CERTIFICATE OF APPROPRIATENESS

Property: 510 Highland St, Houston, TX, 77009; Tract 2 & 3A, Block 20, Woodland Heights Subdivision. The property includes a historic 1,718 square foot one-story wood frame residence and a detached garage situated on a 5,000 square foot (50' x 100') interior lot.

Proposal: Alteration & New Addition

Recommendation: Approval

Figure 2- Typical grade beam detail

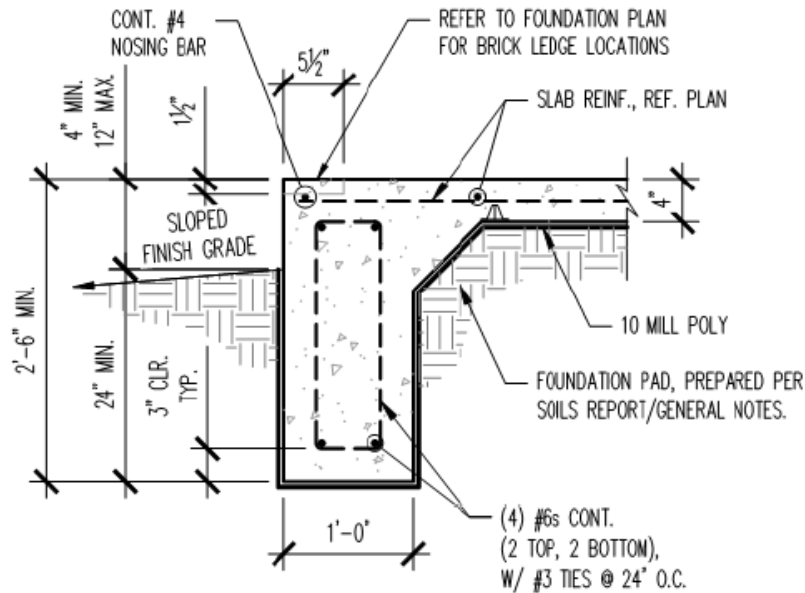
Based on these presumptive values, we recommend that the new foundation consist of a minimum 4" thick slab on grade with 12" wide x 30" deep, extending a minimum of 24" below finish grade as shown in **Figure 2**.
